Amendment Notice 3

Licence Number L8558/2011/1

Premises DeGrussa Copper-Gold Project
Mining Tenement 52/1046
MEEKATHARRA WA 6642

Sandfire Resources submitted an application to DWER on 14 November 2018 to amend the Licence for construction and operation of Stage 4 and 5 lifts of the DeGrussa Tailings Storage Facility (TSF).

Figure 2: TSF Stage 4 and 5 – general layout.

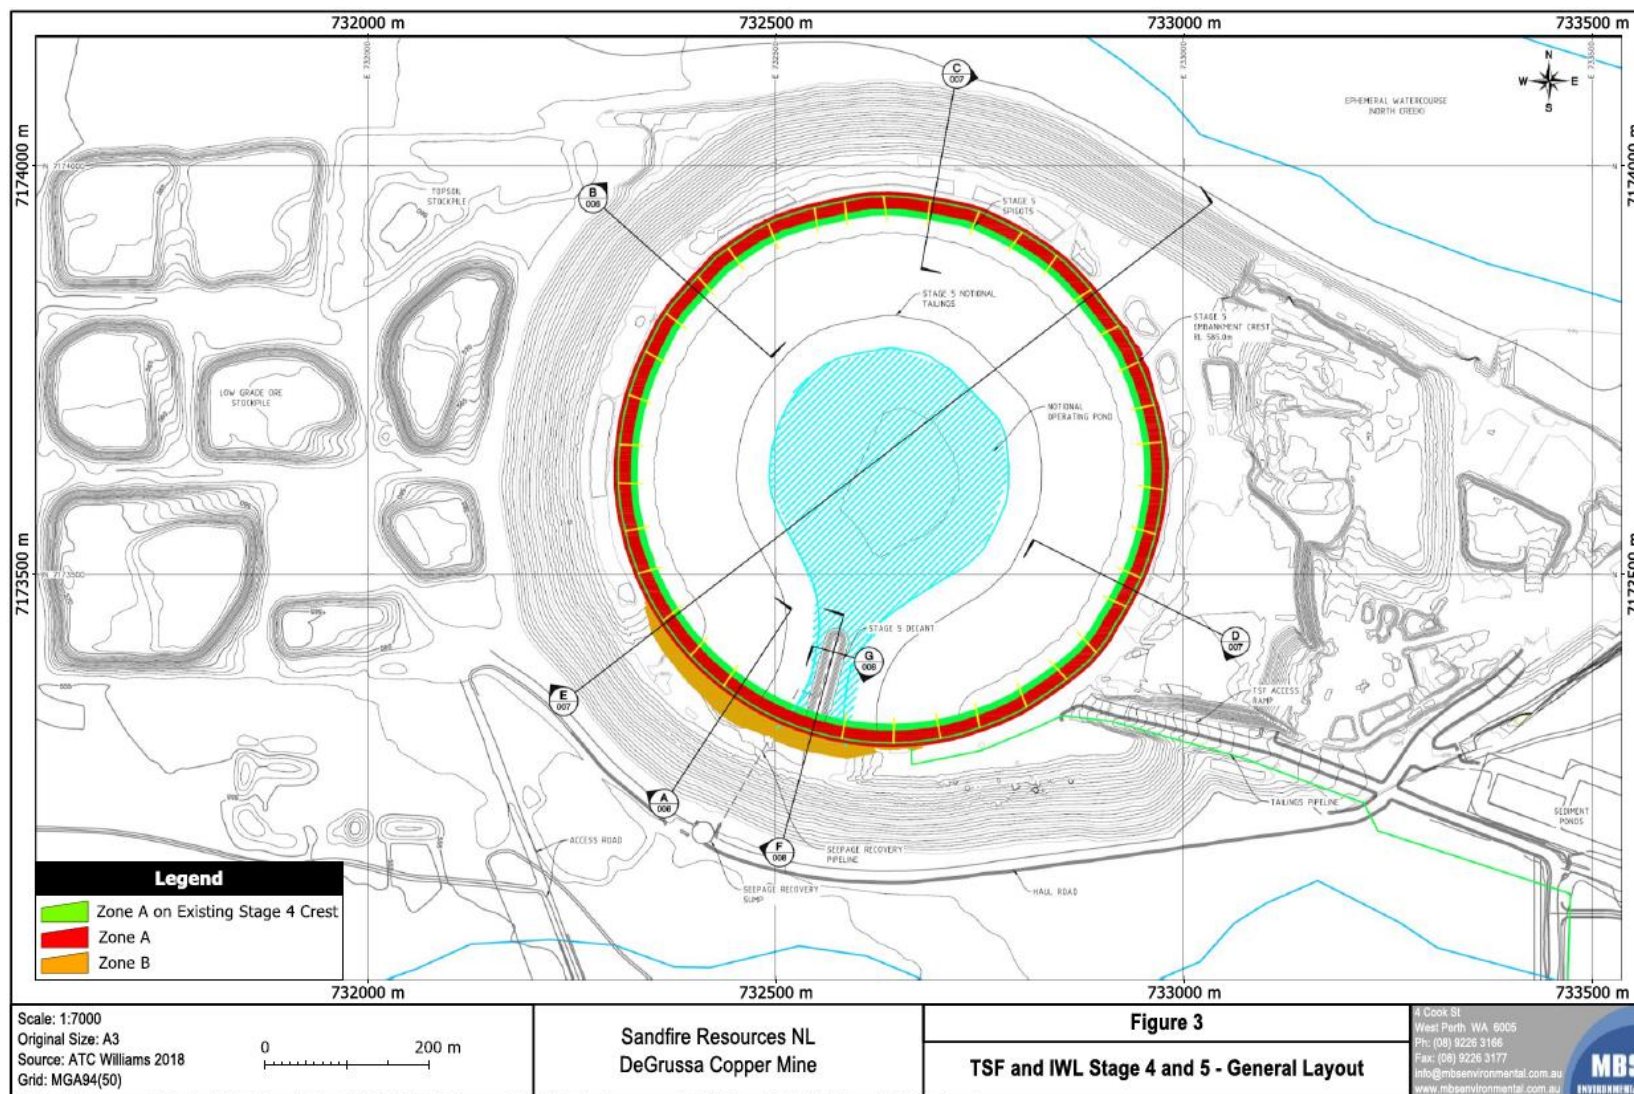
The existing TSF is anticipated to reach storage capacity by June 2019. Sandfire proposes to raise the TSF perimeter embankments via a further two x 5 metre (m) lifts (Stage 4 and Stage 5) to increase the tailings storage capacity on site.

Construction of the two lifts will increase the TSF embankment height from 17 m to 27 m above ground level, and the final height of the TSF within the IWL height of 35 m.

Each lift of the inner containment zones will be laid back against the surrounding mine waste, and HDPE liner will be extended up the face of the Zone A lifts (see Figures 2 & 3) and anchored in a trench around the inner perimeter. To facilitate a two-stage lift and anchoring of the HDPE, a 10 m wide bench excavation will be required into the Zone B upstream slopes of the existing landform (Figures 2 and 3). Material from the excavation will be used to construct infill Zone B embankments in a surface depression in the southern section of the waste rock perimeter.

Figure 3: TSF embankment design

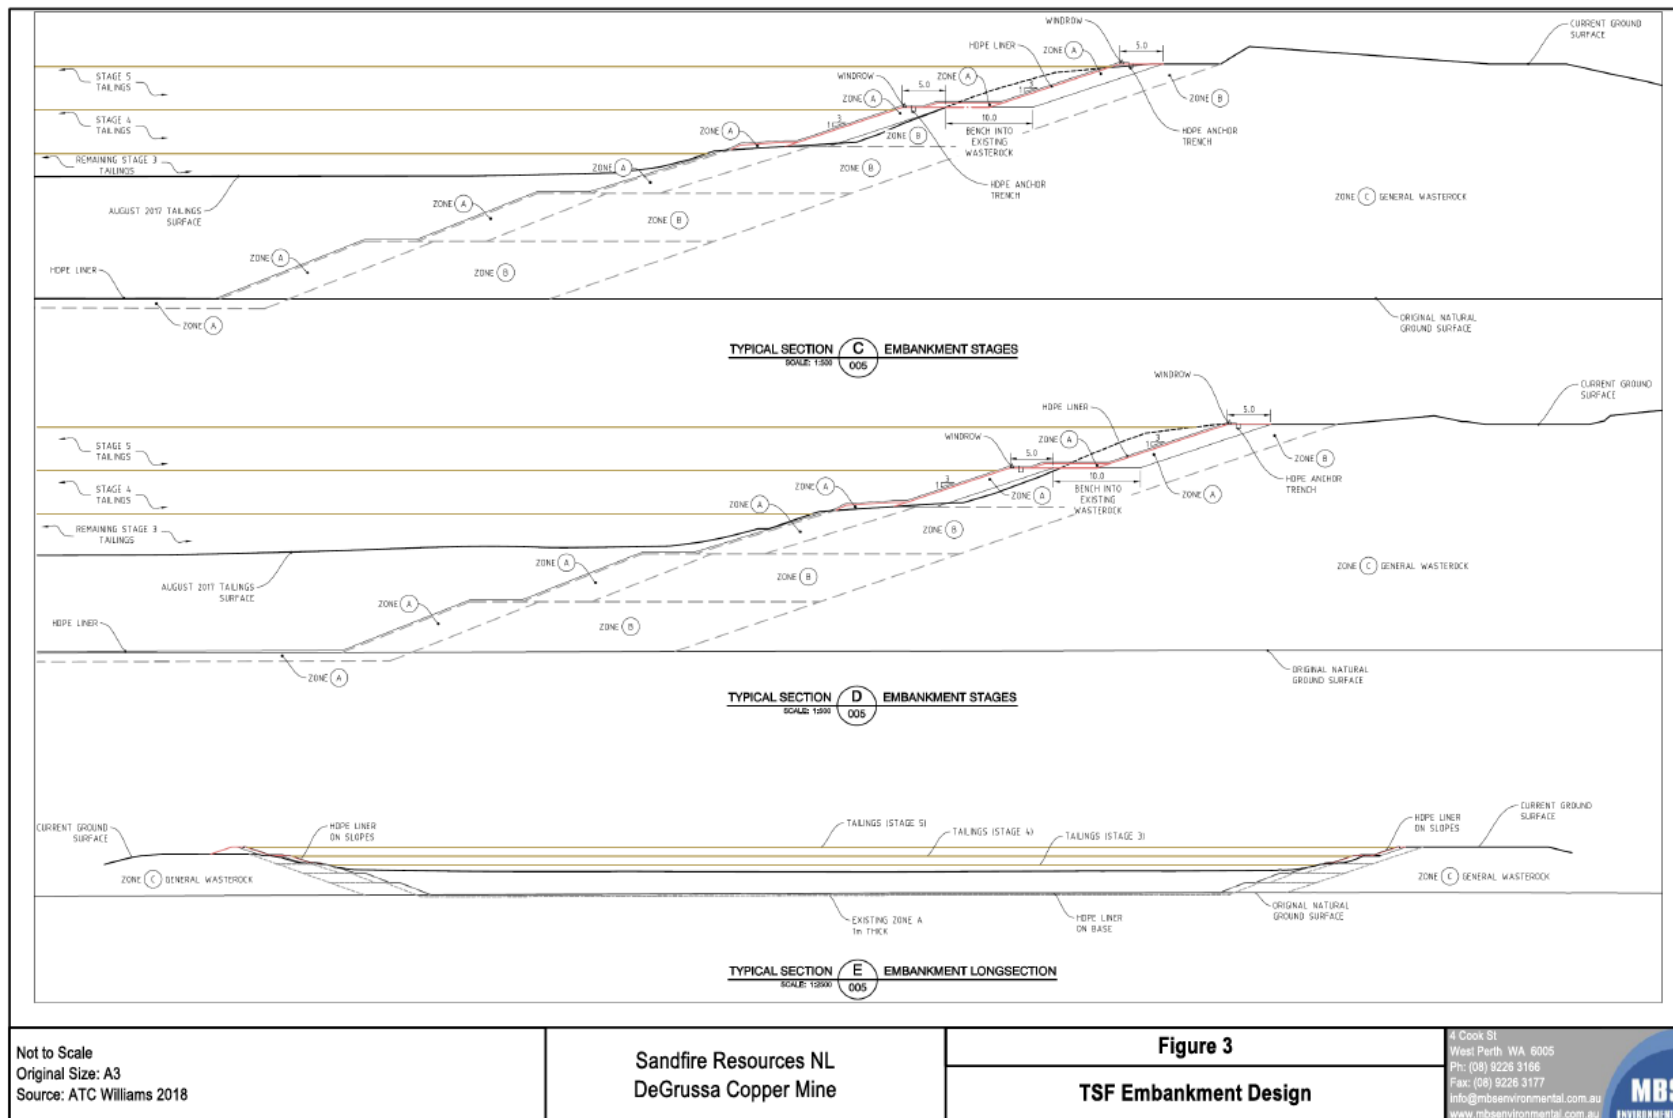
The Stage 4 and Stage 5 embankment liner system will be similar to the existing TSF design. The composite liner system will be extended up the inner slopes of the facility and consist of:

- Zone C – general waste rock with a hydraulic conductivity of 10^{-5} m/s.
- Zone B – track rolled mine waste providing a hydraulic conductivity of 10^{-6} m/s.
- Zone A – compacted homogeneous low permeability material providing a hydraulic conductivity of greater than 10^{-7} m/s (5 m width).
- HDPE – 1 mm HDPE with hydraulic conductivity of greater than 10^{-12} m/s.

Map of TSF Stage 4 and 5 – general layout

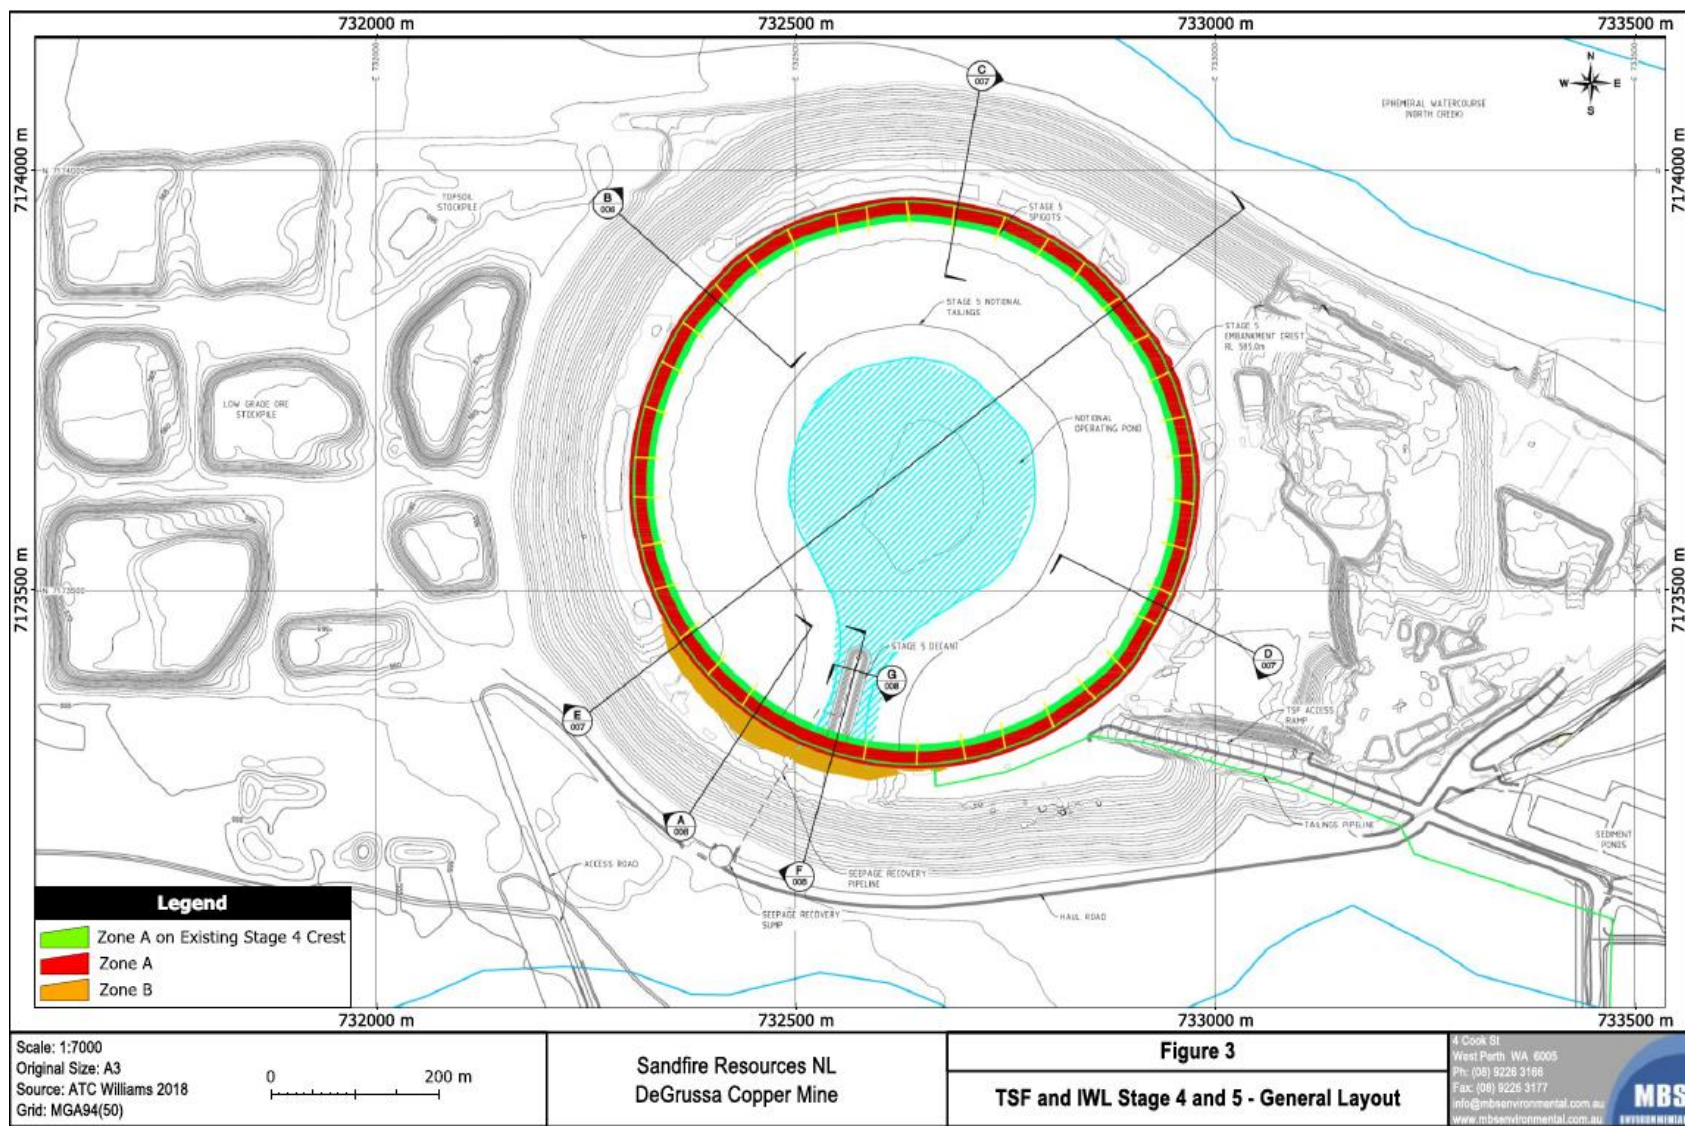
1. The Licence is amended by the insertion of the following Condition 1.3.10:

1.3.10 The Licensee must construct and undertake the Works for the infrastructure and equipment specified in Column 1 to the requirements specified in Column 2, of Table 1.3.7 below:

Table 1.3.7: Construction Requirements	
Column 1	Column 2
Infrastructure/Equipment	Requirements (design, construction and location)
TSF embankment Stage 4	Embankment crest elevation 580.0 m RL
TSF embankment Stage 5	Embankment crest elevation 585.0 m RL Final landform height 27 m (within IWL height of 35 m)
TSF Embankment Design - Stage 4 and Stage 5	Constructed as depicted in Schedule 1: Maps: “Map of TSF Stage 4 and 5 – general layout” and “TSF Design – Sections” (both from <i>Mining Proposal for TSF Embankment Raise (Stages 4 and 5) DeGrussa Copper Mine - M52/1046</i> , prepared by MBS Environmental, November 2018). Zone A - 5 m width and constructed of compacted low permeability material (permeability of greater than 10^{-7} m/s), overlain by a 1 mm thick HDPE liner (permeability greater than 10^{-12} m/s). Each lift of the inner containment zones laid back against the surrounding mine waste and HDPE liner extended up the face of the Zone A lifts and anchored in a trench around the inner perimeter.

TSF Stage 4 and Stage 5	Each Stage constructed and designed to contain up to 1.2 million cubic metres additional tailings storage, and provide sufficient stormwater capacity to hold rainfall

associated with a 1 in 100 year Annual Exceedance Probability 72 hour event, plus a 0.5 m freeboard.
TSF underdrainage collection system	Underdrainage collection system extends along the upstream toe of the Stage 1 embankment, maintained during construction and operation of Stage 4 and Stage 5.
Tailings distribution	The existing decant tower raised. Existing pipelines and spigot system lifted onto the Stage 4 and Stage 5 inner embankments.
